TABLE A
RESOLUTION SUMMARY of JUNE 4, 2019 CATE STREET EXTENSION ROADWAY DESIGN PEER REVIEW #2

RE: Response to Cate Street Extension Peer Review Comments, June 3, 2019
Response to Cate Street Extension Traffic Study - Peer Review Comments, June 3, 2019

Bartlett Street looking south through the railroad overpass toward Islington Street – Low Clearance 12'6"

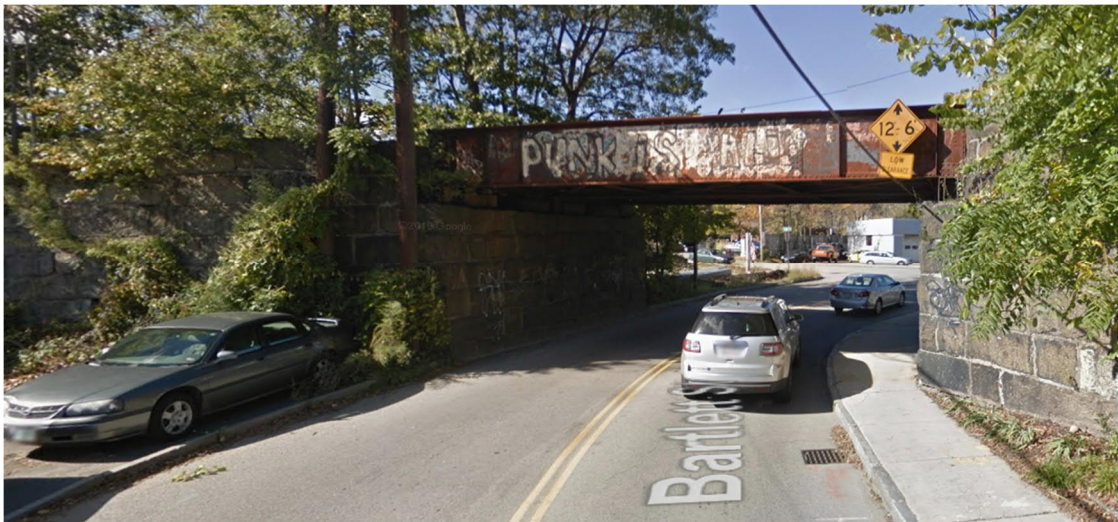
The photos on the following page illustrate both the limitations created height and width wise by the overpass and, in the second photo, the proximity to Cate Street which will be re-aligned to curve into the overpass.

The Low clearance at this location will limit truck traffic as well. Trucks will need to turn north onto Bartlett Street from Cate Street. Large trucks will not be able to clear the overpass due to height.

The final curve on Cate Street that approaches the Railroad Overpass before Islington Street to the southeast is 110-ft. This curve cannot be posted for speeds above 20 mph. Further it would be unsafe in our opinion to do so due to the narrow opening of the overpass and the imposing construction.

Drivers coming from the intersection at Islington north through the overpass to Cate Street and Bartlett Street will have limited sight distance. Increased design speeds headed to this intersection will exacerbate the situation for these drivers further impacting decision time for them as they judge turning onto Cate Street and or Bartlett Street.

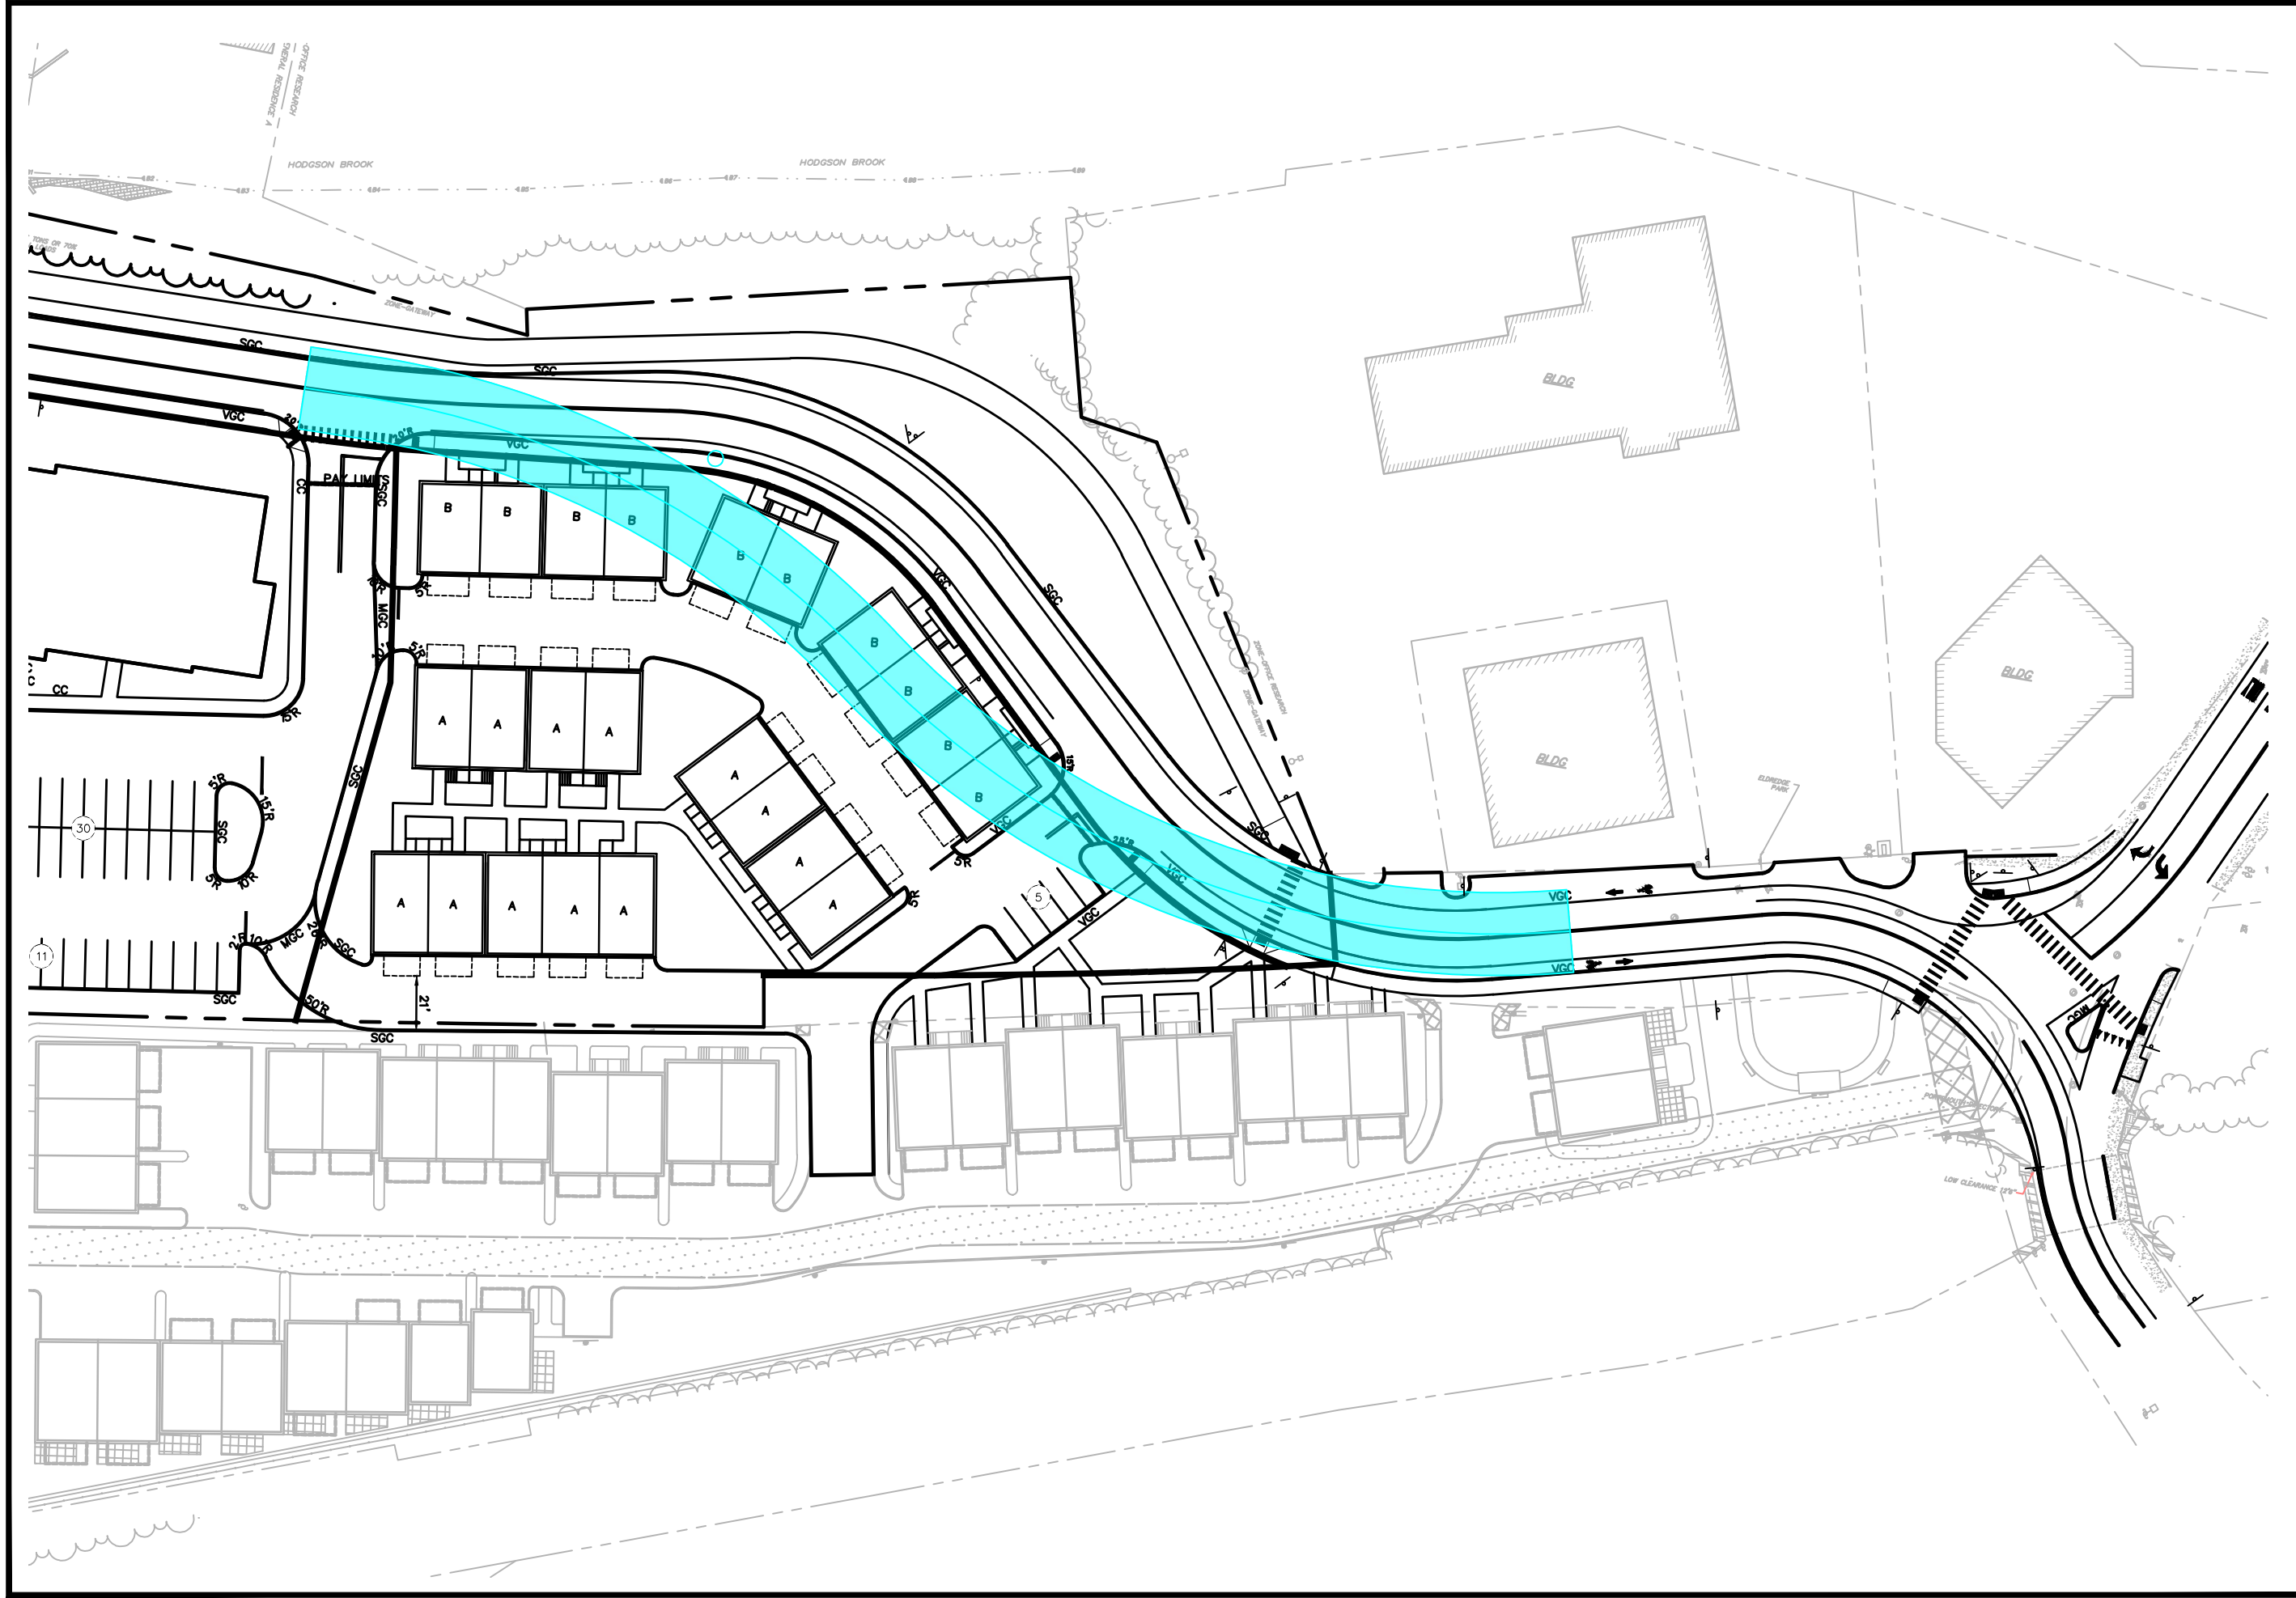
Larger radii reverse curves were explored. See exhibits attached to this letter.

Mr. Eby agreed that eliminating the tangents was not a satisfactory design outcome. He echoed our concerns that it limits driver's ability to transition between curves and direction changes.

With the addition of the appropriate signage for the curves as in the revision, the correct signage for the mid-block crosswalks and well as the desire to maintain tangent and curves with no superelevation, it is our opinion that the design is justified as proposed. Any increase in curve radius would not provide any noticeable benefit.
